**Committee of Experts on the Transport of Dangerous Goods
and on the Globally Harmonized System of Classification
and Labelling of Chemicals****Sub-Committee of Experts on the Transport of Dangerous Goods****Thirty-eighth session**

Explosives and related matters**Changes to screening test for substances that may have
explosive properties****Transmitted by the expert from Japan and by the International Council
of Chemical Associations (ICCA)¹**

Comparison of the exothermic decomposition energies measured by DSC (Q_{DSC}) and adiabatic calorimetry (Q_{adia}) over 11 kinds of chemical substances. ARC type instrument was used for adiabatic calorimetry.

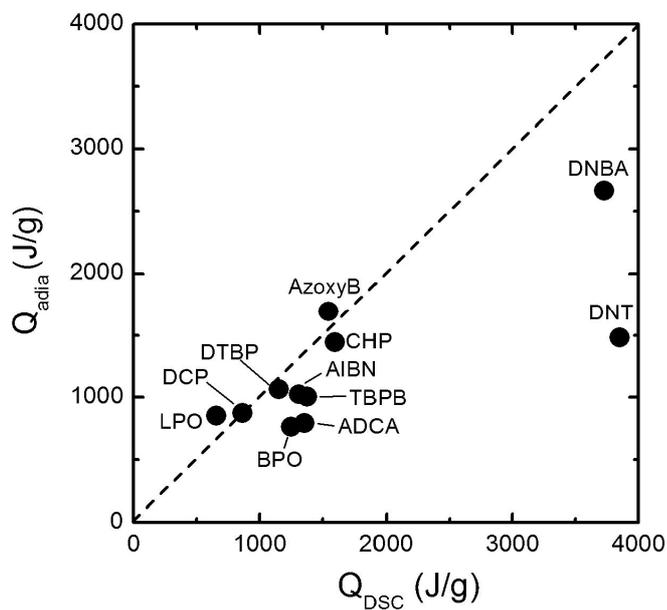
6. In practice, as shown in Annex of this document, test measurements over 11 kinds of chemical substances show considerable disagreements between Q_{DSC} and Q_{adia} , which are the exothermic decomposition energies measured by DSC and adiabatic calorimetry, respectively.
7. Moreover, observed values of Q_{adia} have a tendency to be lower than those of Q_{DSC} suggesting that the adiabatic calorimetry tends to underestimate the exothermic decomposition energy.
8. This finding is not surprising but can be scientifically explained: Main factors are the heat loss and the response time of the equipment (i.e. the method is only near adiabatic).
9. Therefore, it is suggested that the adiabatic calorimetric techniques should not be used to determine the thermal decomposition energy of substances and mixtures.

10. We propose that the Sub-Committee consider exclusion of the adiabatic calorimetric techniques from the methods to determine the thermal decomposition energy of substances and mixtures in the next biennium. Possible amendments to subsection 20.3.3.3 of the Manual of Tests and Criteria are as follows:

~~“Thermal stability and exothermic decomposition energy may be estimated using a suitable calorimetric technique such as differential scanning calorimetry or adiabatic calorimetry. In using such techniques, special~~ Special care should be taken in interpreting the results when:

~~“If differential scanning calorimetry is used, the~~ The extrapolated onset temperature is defined as being the point of intersection of the tangent drawn at the point of greatest slope on the leading edge of the peak with the extrapolated baseline.”.
